**Planning and Zoning Commission Permit Application**  
 For Submission to the PZC

**RECORD ID:** PZC-25-6  
**Activity Being Applied For:** Subdivision  
**Project Description:** 3 Lot Subdivision

Review Memorandum

**See the attached marked-up site plan provided by Todd Penney, P.E., which provides an accompaniment to this memo.**

SUBDIVISION PLAN

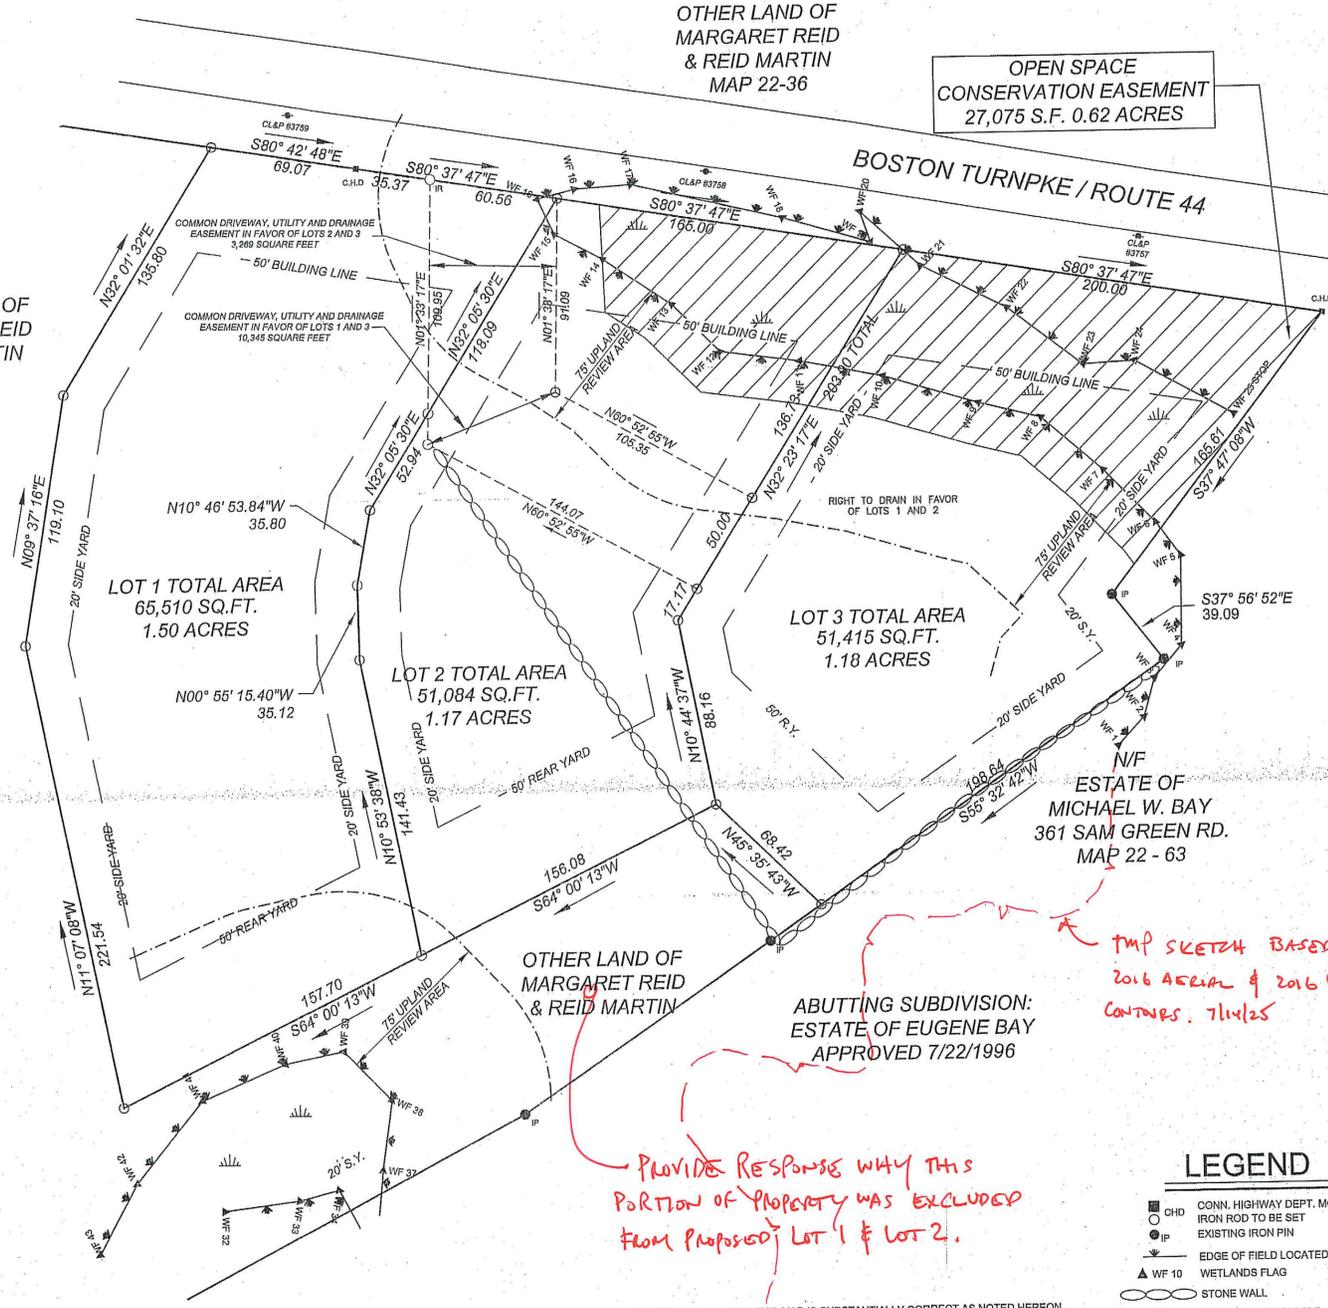
*ADD EXISTING TOPOGRAPHIC DATA.  
\* ARE THERE ANY IMPROVEMENT THAT MIGHT BE INCORPORATED TO IMPROVE STORMWATER QUALITY TO WETLAND.*

GRADING / E & S PLAN

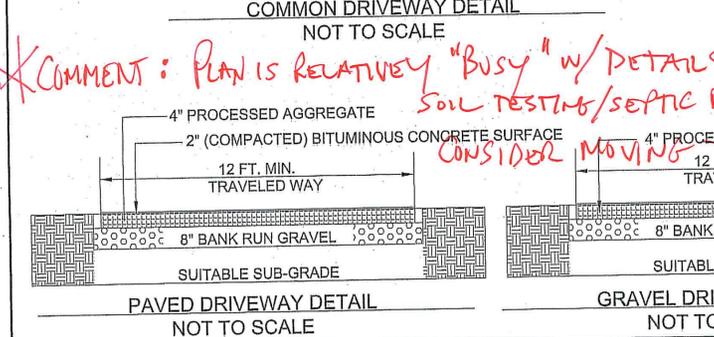
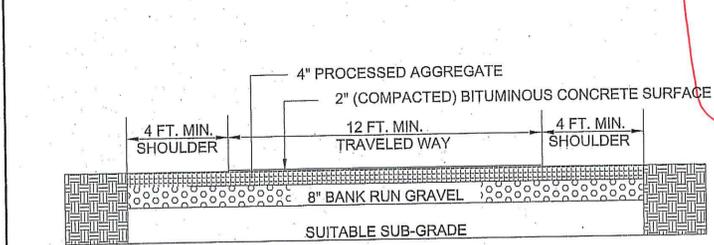
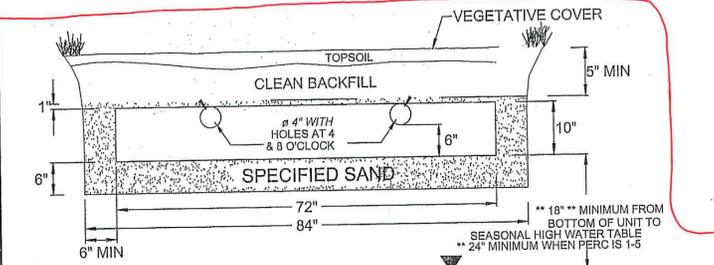
*\* COMMENT: PLAN IS RELATIVELY "BUSY" W/ DETAILS AND SOIL TESTING/SEPTIC DESIGN DATA CONSIDER MOVING TO SHEET 4. MAYBE A 30' SCALE CAN BE USED TO MAKE IMPROVEMENTS EASIER TO EVALUATE.*

ADD EXISTING TOPO  
ADD PROPOSED TOPO

\* MOVE TO DETAIL SHEET

STORMWATER MANAGEMENT PLAN

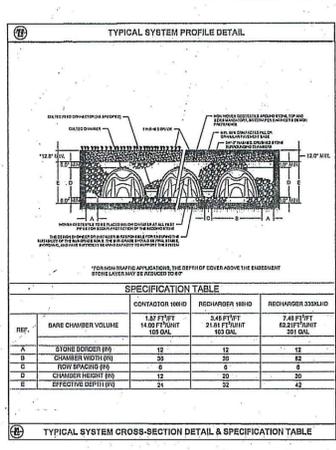
IT APPEARS AS IF DRIVEWAY IS LOWER THAN INFILTRATION TRENCH. PROVIDE MORE SPOT ELEVATIONS THIS DOES NOT CORRESPOND W/ DRAINAGE COMPS. DOES INFILTRATION TRENCH OVERFLOW TO GRASS SWALE?

I BELIEVE THIS WILL BE THE RUNOFF PATH AT THE OUTLET. IS THAT YOUR INTENT?

DEPICT TANK AND SEWER LINE

DEPICT TANK AND SEWER LINE

DEPICT TANK AND SEWER LINE

PROVIDE RESPONSE AS TO WHY SEPTIC CANNOT BE SHIFTED OUT OF U.R.A.

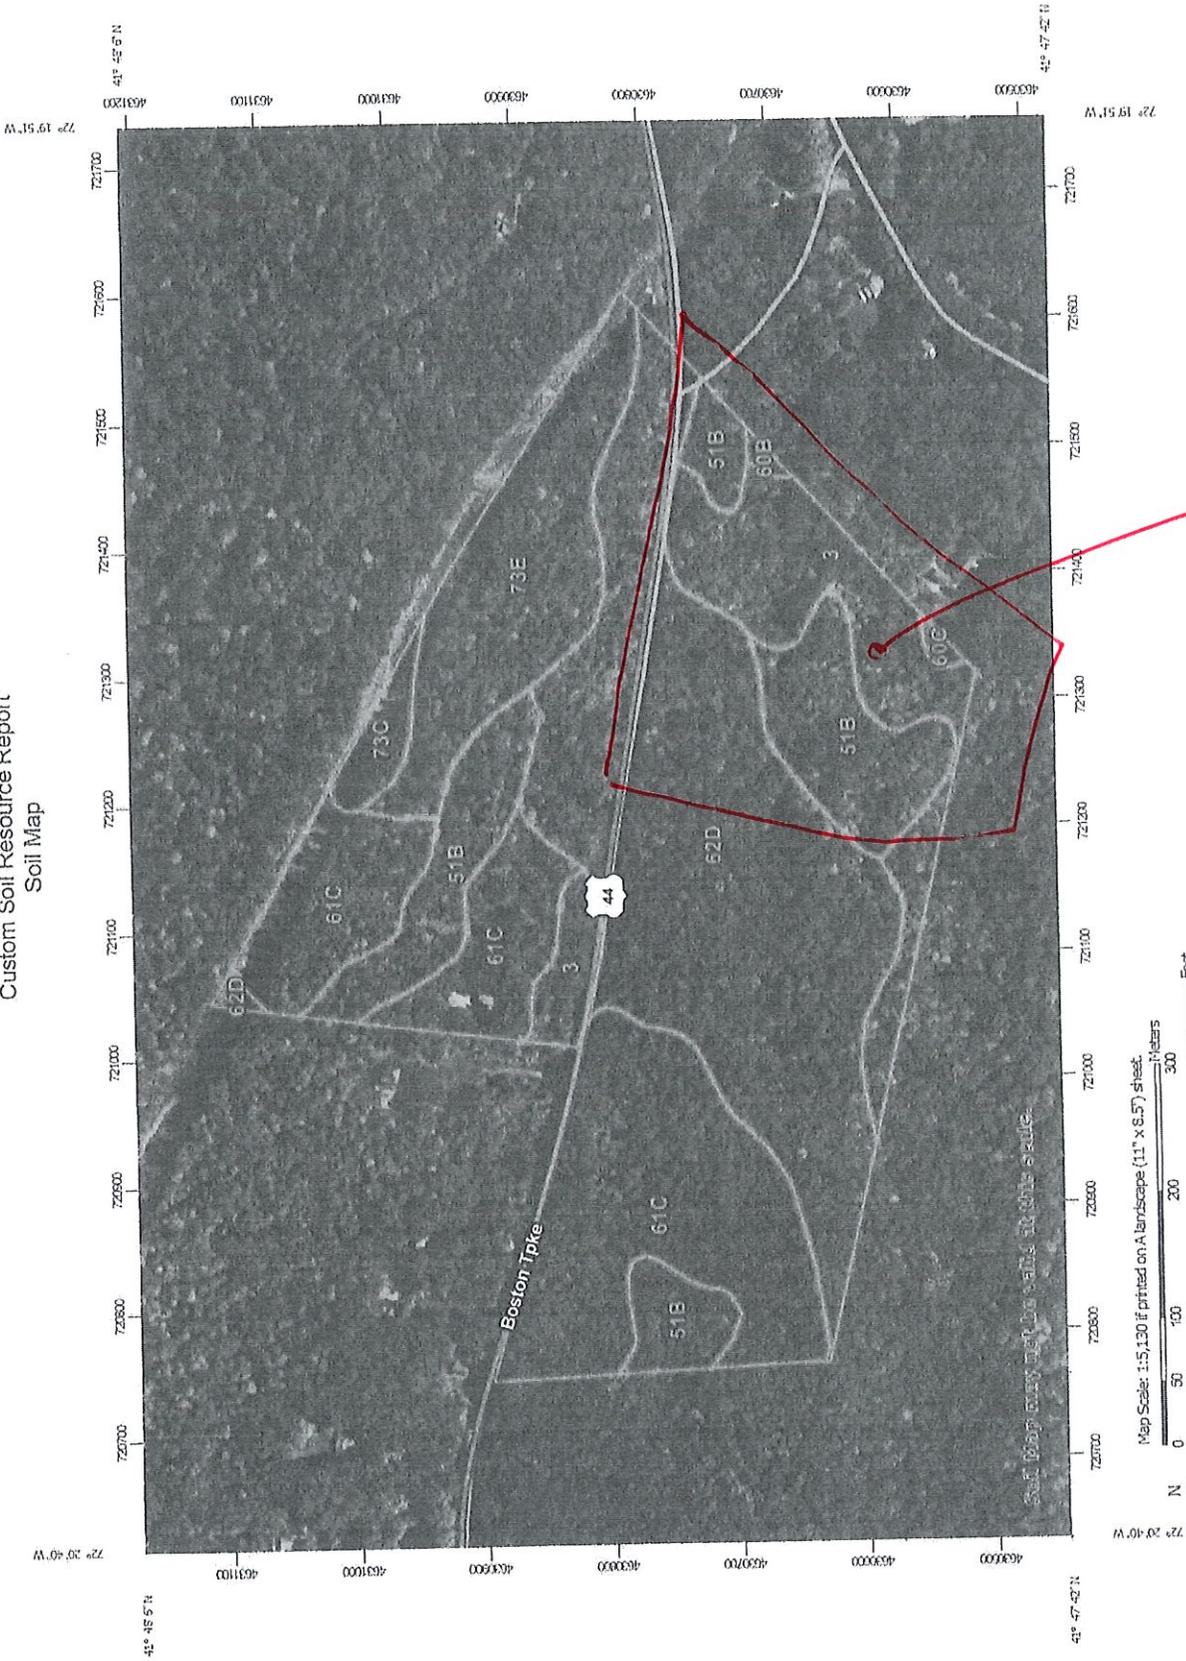
\* PROVIDE COMMENT ON HOW SITE ADDRESSES PEAK STORM EVENTS.  
**Project Overview:** This narrative is intended to describe the erosion and sediment control methods and the stormwater management measures to be used during the construction of a 3 lot residential subdivision and its associated buildings and driveways. Soil erosion and sediment controls will be provided to control impacts during construction and shall be in conformance with the methods outlined in the *2024 Connecticut Guidelines for Erosion and Sediment Control Manual*. The stormwater management measures are planned to mitigate the increase in impervious areas resulting from the proposed construction and will provide collection, treatment and infiltration of the first 1.3" of rainfall (Water Quality Volume – WQV) in a manner consistent with the *2024 Connecticut Stormwater Quality Manual*.

\* PROVIDE A PLAN/FIG.  
W/ PROPOSED IMPERVIOUS  
COVERAGE DEPICTED

*PROVIDE BACKUP TO THIS NUMBER? (4.25 AC)*

PLAN CALLS FOR 15" WHICH IS CORRECT?
